FIRE SAFETY INSPECTION REPORT

Rose Intimates Ltd.

ACCORD ID: 23351

Date: 8 January 2019

F-3 Fire Rated Construction

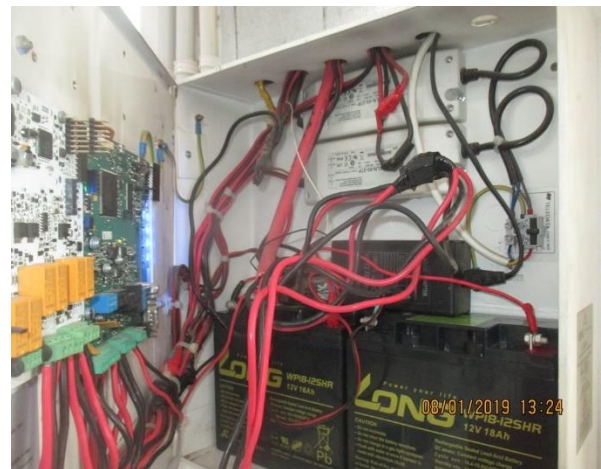
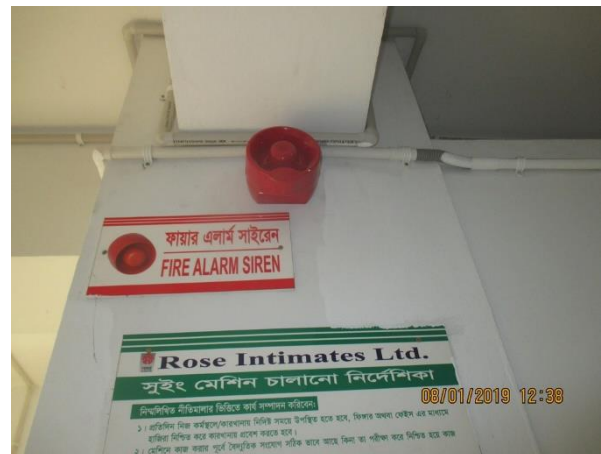
Unsealed electrical penetration is located in the fire rated partition walls and floor/ceiling assemblies.

Seal all penetrations in wall and floor/ceiling assemblies to maintain the required fire separation.
